HUTSON-KEY SUBDIVISION

APPLICATION NUMBER Holdover DATE January 22, 2004
APPLICANT Hutson-Key Subdivision
REQUEST Subdivision

DETAIL SITE PLAN

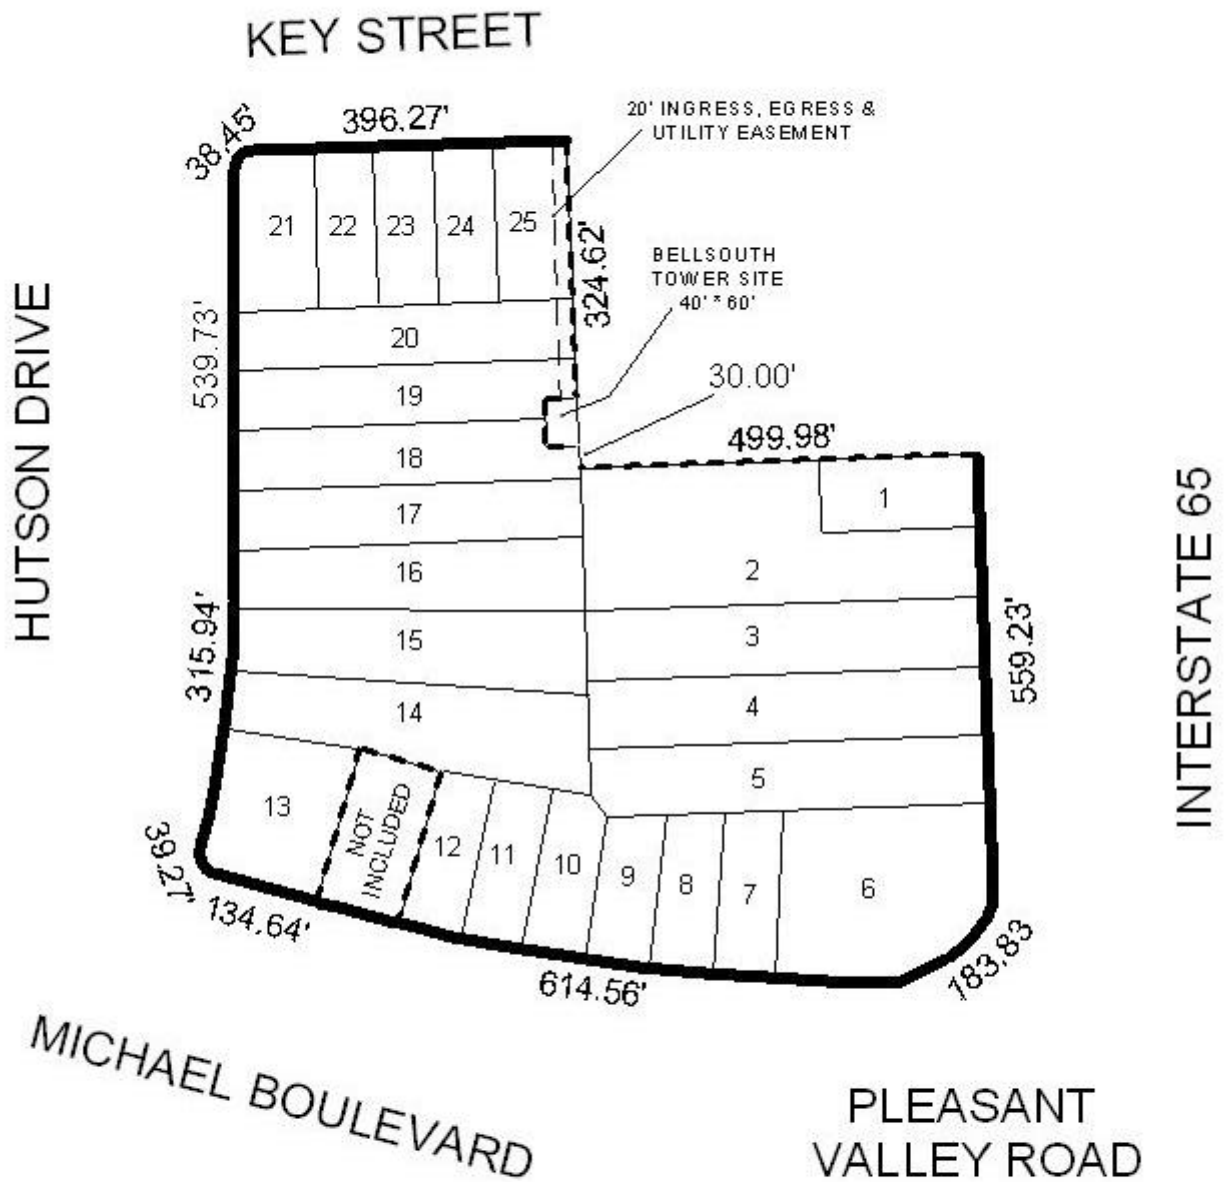
Interstate 65, which is illustrated as a variable right-of-way, is shown as a major street on the Major Street Plan, and as such requires a 300-foot right-of-way; therefore, the dedication of any necessary right-of-way to provide 150-feet from the centerline should be required. As a means of access management, a note should be placed on the final plat stating that Lots 1-5 and all corner lots (Lots 6, 13 and 21) are limited to one curb cut each, with the location and design to be approved by Traffic Engineering.

Moreover, as Lots 6, 13 and 21 are corner lots, the dedication of a 25' radius should be required. Lots 2 through 5 and Lots 14 through 20 would exceed the width to depth ratio; therefore, a waiver of Section V.D.3. would be required.

The 25-foot minimum building setback lines are not shown but would be required on the final plat.

With a waiver of Section V.D.3., the proposed plat meets the minimum requirements of the Subdivision Regulations and is recommended for Tentative Approval subject to the following conditions: 1) the dedication of any necessary right-of-way to provide 150' from the centerline of Interstate 65; 2) the placement of a note on the final plat stating that Lots 1-5 and all lots located on a corner (Lots 6, 13 and 21) are limited to one curb cut each, with the design and location to be approved by Traffic Engineering; 3) the dedication of a 25' radius on all corner lots; and 4) the placement of the 25-foot minimum setback lines on the final plat.
